STAFF REPORT
COMMUNITY DEVELOPMENT DEPARTMENT

HEARING DATE: September 17, 2020
 Continued from July 16, & August 20, 2020

SUBJECT: H-2020-0047
 Prescott Ridge – AZ, PP, PS, ALT

A. Master Plan Conceptual Rendering & Medical Campus Conceptual Development Plan – **NOT APPROVED**

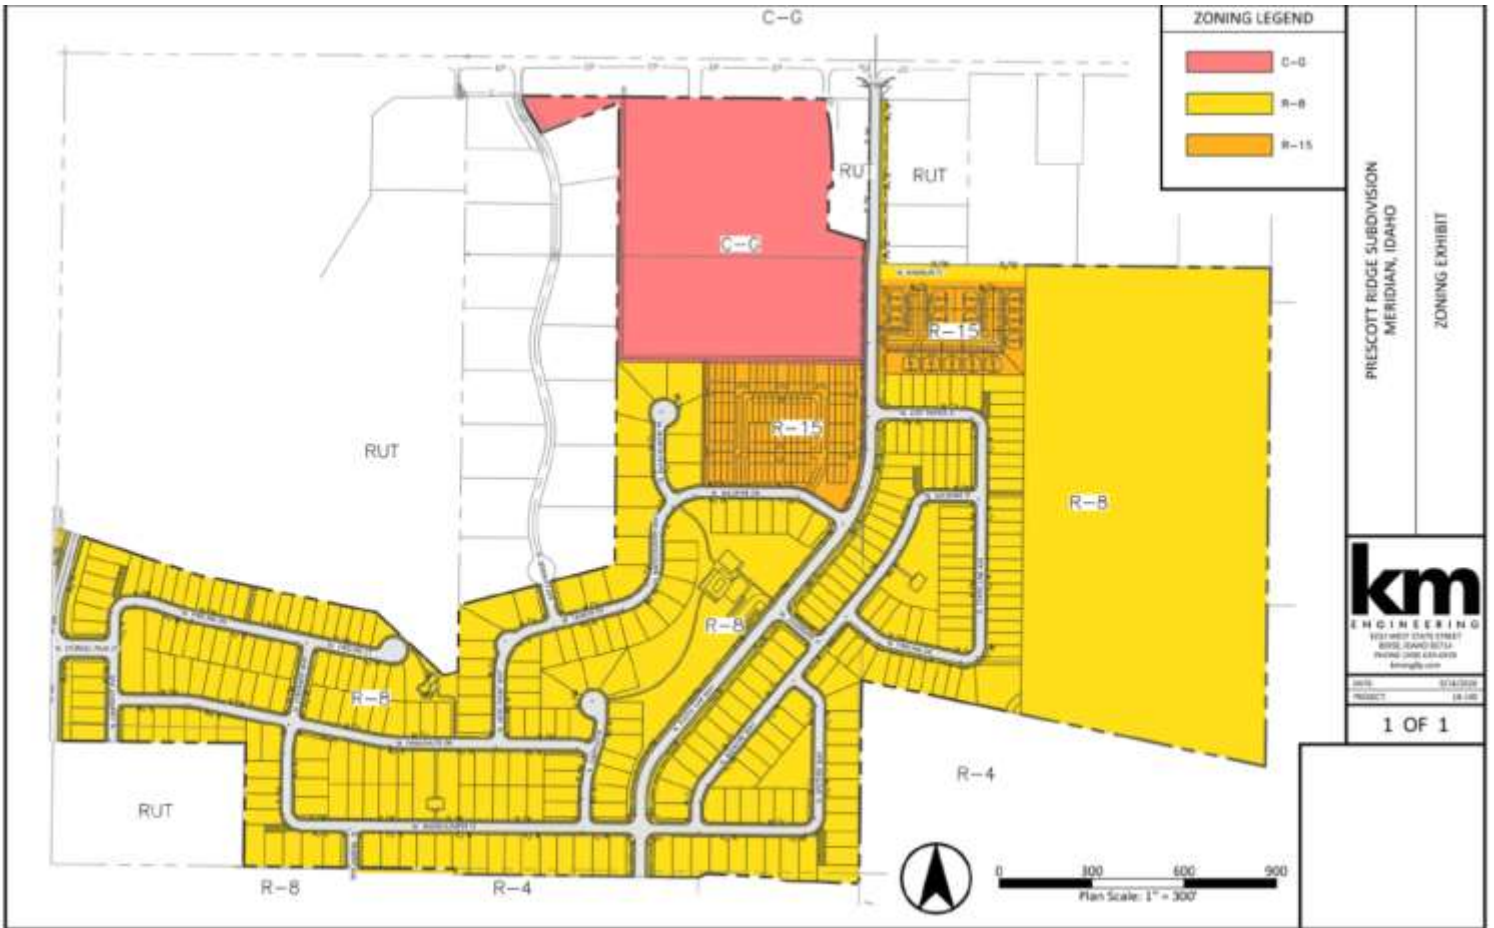
A Master Plan is proposed with the annexation request which will be incorporated into a Development Agreement to ensure future development is consistent with the Mixed Use designation. Staff recommends changes to the Master Plan as noted in Section IX consistent with the development guidelines for Mixed Use designated areas in the Comprehensive Plan.

- “Supportive and proportional public and/or quasi-public spaces and places including but not limited to parks, plazas, outdoor gathering areas, open space, libraries, and schools are expected; outdoor seating areas at restaurants do not count.”
*A school is planned to develop on the eastern portion of the annexation area but it outside the Mixed Use designated area and not being developed with this project. **To ensure such spaces and places are included in the mixed-use portion of the development as desired, Staff recommends the concept plan is revised accordingly prior to the City Council hearing.***

- “Mixed use areas should be centered around spaces that are well-designed public and quasi-public centers of activity. Spaces should be activated and incorporate permanent design elements and amenities that foster a wide variety of interests ranging from leisure to play. These areas should be thoughtfully integrated into the development and further placemaking opportunities considered.”
*No such spaces or design elements/amenities are proposed. **To ensure future development in the MU-R designated area is consistent with this guideline, Staff recommends the concept plan is revised accordingly prior to the City Council hearing.***

Staff believes the proposed development plan is generally consistent with the vision of the Comprehensive Plan if a commercial (i.e. retail, restaurant, etc.) component is included in the mixed use designated portion of the development as discussed above.

The conceptual development plan for the commercial, C-G zoned portion of the site, shall be revised and submitted to the City Clerk at least 10 days prior to the City Council hearing to reflect conformance with the following guidelines in the Comprehensive Plan for Mixed Use developments:

- The buildings in the commercial C-G zoned portion of the development shall be arranged to create some form of common, usable area, such as a plaza or green space in accord with the mixed use guidelines in the Comprehensive Plan (pg. 3-13).

- Supportive and proportional public and/or quasi-public spaces and places including but not limited to parks, plazas, outdoor gathering areas, open space, libraries, and schools shall be provided in the Mixed Use designated portion of the site; outdoor seating areas at restaurants do not count (pg. 3-13). *The school planned on the eastern portion of the annexation area does not satisfy this requirement as it is not part of the Mixed Use designated area.*

- A commercial land use type shall be included on the plan in the MU-R designated area (includes retail, restaurants, etc.).

C. Preliminary Plat (date: 8/28/2020), Phasing Plan & Lot Layout Exhibit

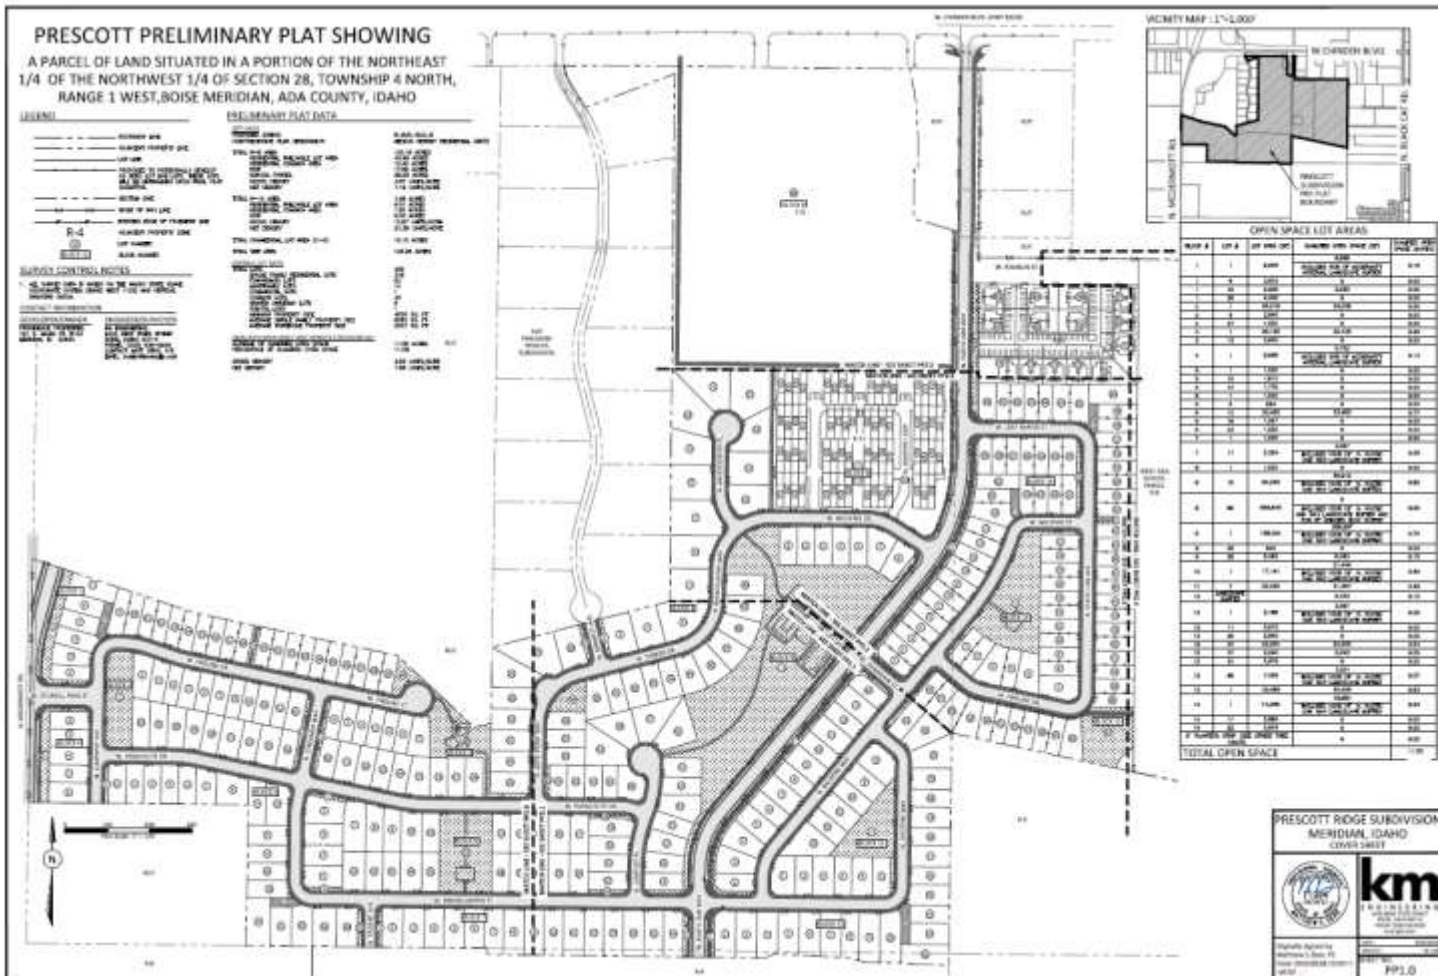
The lot layout/development plan for the townhome portion of the development on Lots 16-79, Block 8 is not consistent with UDC standards as it depicts common driveways for access to homes off the private street, which is prohibited per UDC 11-3F-4A.6; additionally, each common driveway may only serve a maximum of (6) dwelling units per UDC 11-6C-3D – 8 units are proposed off each driveway. Private streets are not intended for townhome developments other than those that create a common mew through the site design or that propose a limited gated development – neither mews nor gates are proposed (alternative compliance is requested to this standard – see analysis below in Section VI.C, D).

The lot layout/development plan for the multi-family development on Lots 70-83, Block 12 depicts parking and access driveways on buildable lots – the number of parking spaces varies with each lot and are not commensurate with the parking required for each building. Therefore, Staff recommends the access driveways and parking are placed in a common lot with an ingress-egress/parking easement for each buildable lot. A revised plat should be submitted at least 10 days prior to the City Council hearing.

- f. Re-design the townhome portion of the development (i.e. Lots 16-79, Block 8) with public streets (alleys and/or common driveways may be incorporated); or, if private streets are proposed, each unit should front on and be accessed via the private street(s). Alternatively, a multi-family development (i.e. one structure on one property with 3 or more dwelling units) with townhome style units might be a development option for this area. **A revised concept plan shall be presented prior to or at the Commission hearing for review and a revised plat reflecting this change shall be submitted at least 10 days prior to the City Council hearing. If private streets are proposed with a townhome development, a new or gated private streets should be provided in accord with UDC 11-3F-1. Also, provide updated density calculations.**

- g. Lots 70-83, Block 12 in the multi-family portion of the development shall be revised to depict parking and access driveways on a common lot with an ingress-egress/parking easement for each buildable lot. **A revised plat shall be submitted at least 10 days prior to the City Council hearing depicting this change.**

E. Qualified Open Space Exhibit & Site Amenities (dated: 8/26/20)

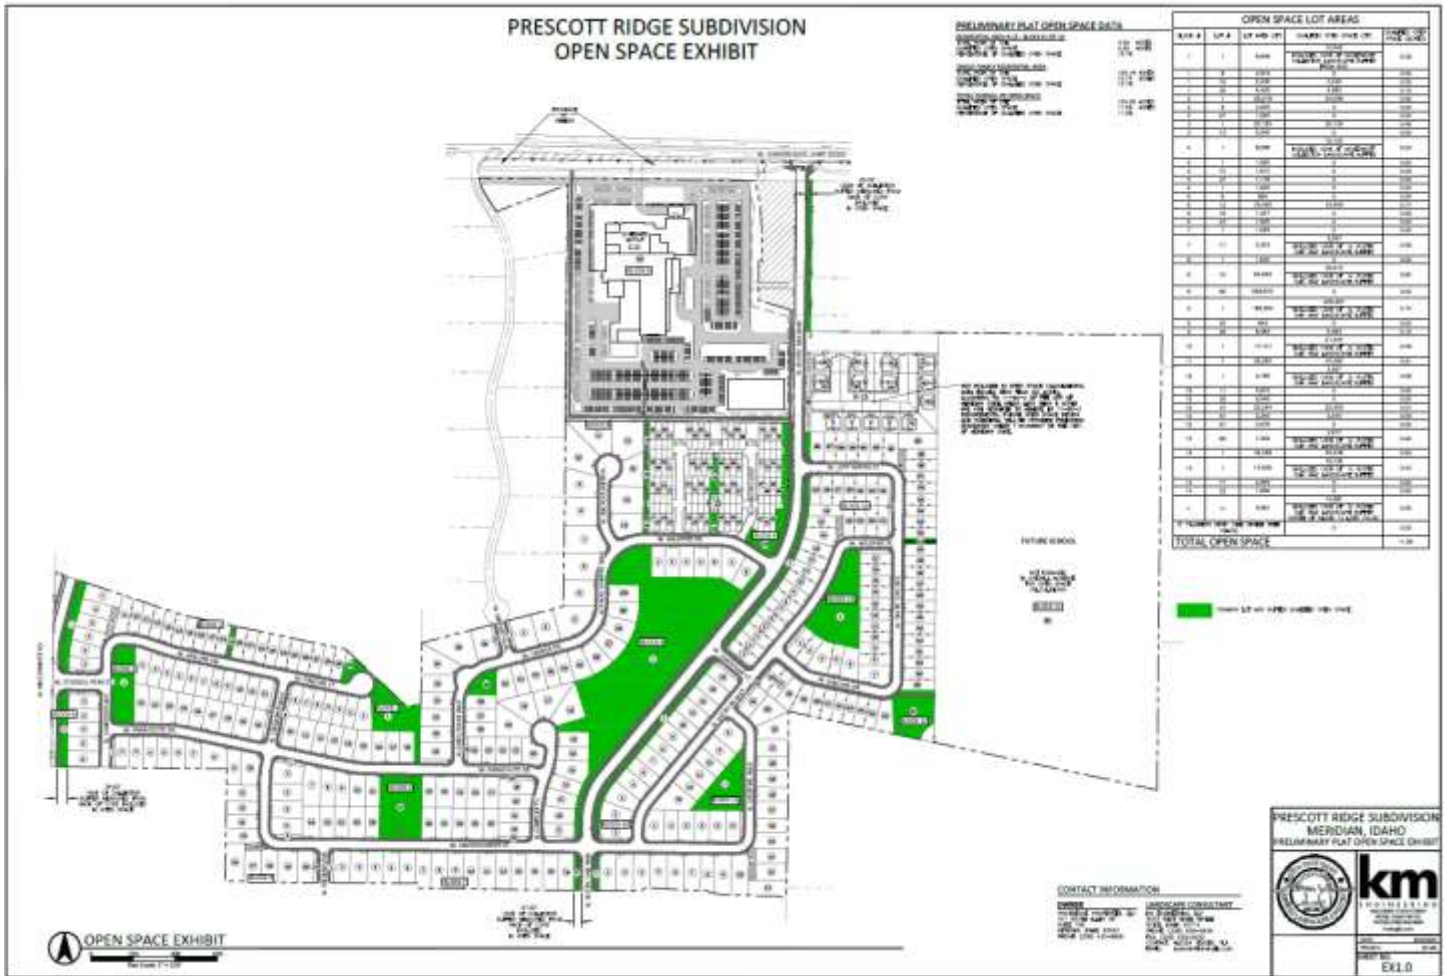
- k. If a dog park is proposed on Lot 1, Block 2, demonstrate compliance with the standards listed in UDC 11-3G-3C.1h.
 - l. Depict a small tot lot on Lot 12, Block 6 rather than a large tot lot, consistent with that shown on the site amenities plan.

F. Parking Plan (dated: 4/8/20) – NOT APPROVED (*Parking for townhome portion needs to be revised*)

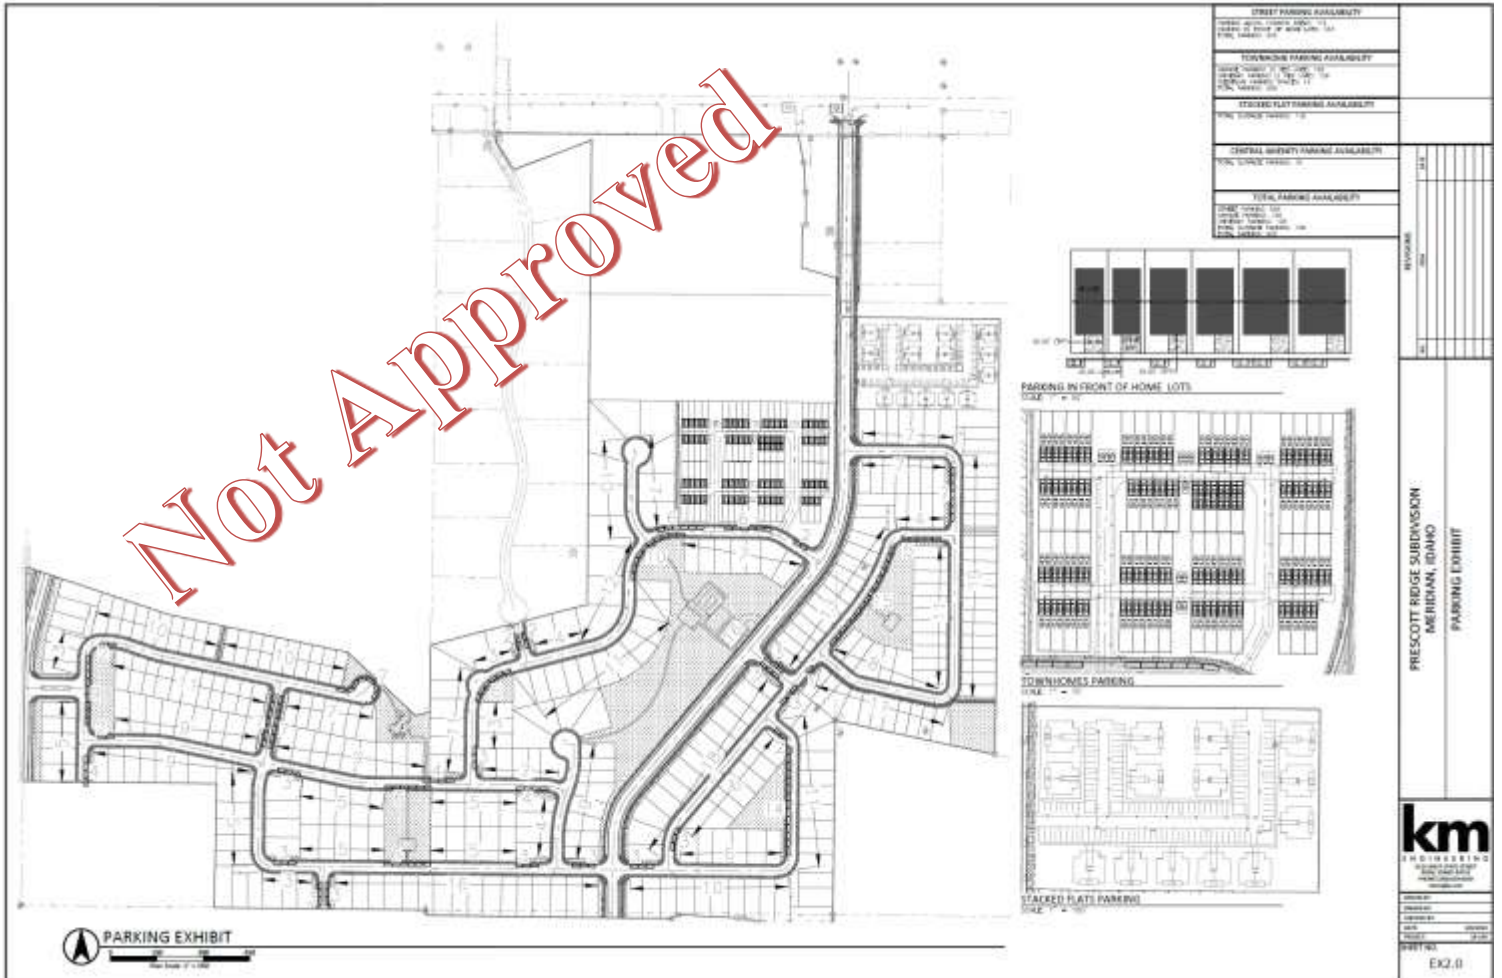
(i.e. one structure on one property with 3 or more dwelling units) with townhome style units might be a development option for this area. A revised parking plan should be submitted for this area as well that provides for adequate guest parking above the minimum UDC standards (Table 11-3C-6) to serve this portion of the development. A revised concept plan and parking plan should be submitted prior to or at the Commission hearing for review and a revised plat should be submitted at least 10 days prior to the City Council hearing that reflects this modification.

5. Off-street parking is required to be provided for residential uses in accord with the standards listed in [UDC Table 11-3C-6](#) and for commercial uses in accord with the standards listed in 11-3C-6B; bicycle parking is required in commercial districts as set forth in UDC 11-3C-6G per the standards listed in UDC 11-3C-5C. **A revised parking plan shall be submitted prior to or at the Commission hearing for the townhome portion of the development that reflects the changes noted above in condition #A.2f and that provides for adequate guest parking to serve this portion of the development.**
